DATE: October 24, 2019

FROM: Geoffrey M. Goll, P.E. & Mark Gallagher

RE: Analysis of Transco's Responses to Public Comments on Its
Freshwater Wetlands Individual Permit application for the Proposed
Northeast Supply Enhancement ("NESE") Project (Program Interest
#: 0000-01-1001.3; Activity #: LUP 190001)

Figure 3: Excerpt of the Compressor Station No. 206 Drainage Area Map (Proposed Conditions) Sheet 4 of 10

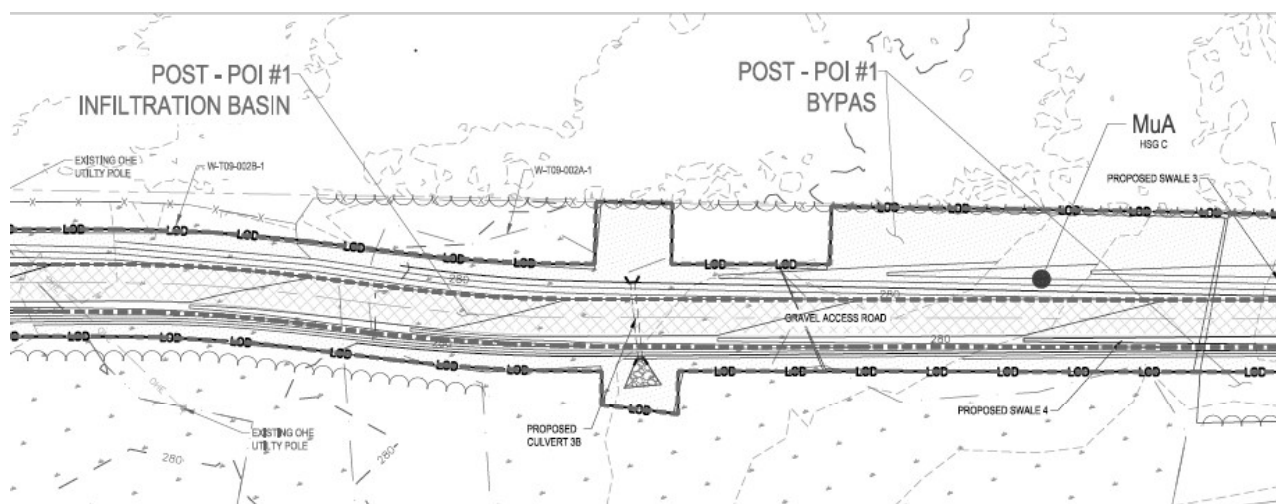
Thus, the gravel road will be compacted, but Transco is still underestimating the runoff. The gravel access roads are delineated by AECOM to approximately the actual edge of gravel (indicated by the red dashes in Figure 3 below) and do not include the vegetated areas associated with right of way of the gravel road. In this case, AECOM is still applying CN values for gravel road with ROW, even though no ROW is included in their drainage area figure. This provides yet another example of the applicant underestimating stormwater runoff.

Figure 4: Sediment Basin Detail (Sheet 11 of 13 of the Soil Erosion and Sediment Control Plans) and Infiltration Basin Detail (on Sheet 8 of 13 of the Post Construction Stormwater Management Plans)

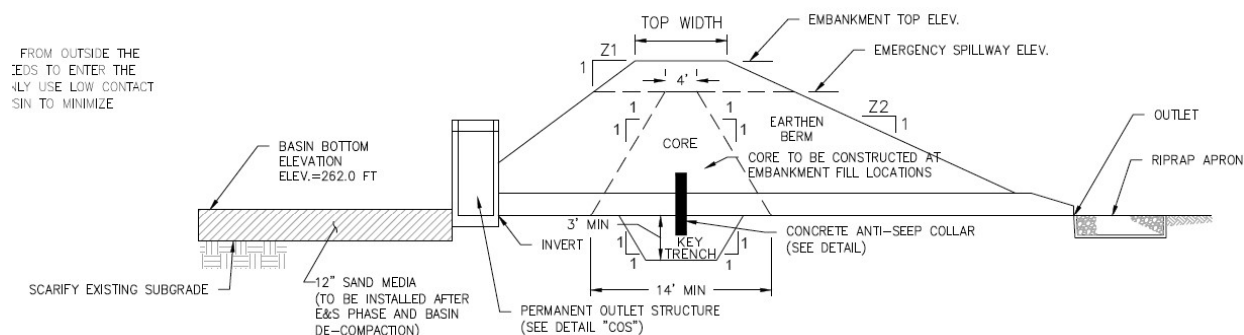
Transco's response to comments is inconsistent with the generalized detail for the construction of the embankment shown in Figure 4 below as well as the plan notes, specifically Note 10 provided in the Erosion and Sediment Control plan set. In order to understand exactly what is being proposed, Transco's design engineer should provide a sufficient level of construction detail to enable a reviewer to understand how the proposed embankment would be constructed. The plan detail clearly shows a core to be constructed in all locations of the embankment fill, but it does not differentiate the material or construction standards between the core and the remaining earthen berm.

The depth of the key trench is stated to be a minimum of 3 feet from the invert of the pipe. Key trenches are incorporated into embankment construction to both reduce the potential for sliding and reduce seepage from bypassing the embankment.

Although the proposed embankment is not currently classified as a dam (as per New Jersey Dam Safety Standards), it should be designed and constructed to meet the standards for new earthen embankments. State dam safety departments rely on the Federal Energy Regulatory Commission (FERC) as the basis for their individual regulations and standards. As such, Chapter 4 ("Embankment Dams") of the "Engineering Guidelines for the Evaluation of Hydropower Projects" -- published by FERC -- is used as reference for design. The design of the embankment must, at a minimum, meet the two criteria set forth below, which will, in turn, reduce the lateral flow of seepage and groundwater.

1. The current embankment does not include seepage control measures discussed in section 4-5.2 of Attachment 3 of this Report ["FERC Chapter 4 – Embankment Dams (Revised Draft Version)"].
2. The current embankment design includes a concrete anti-seep collar, which are no longer recommend (refer to the highlighted section of Attachment 3 of this Report, page 28).
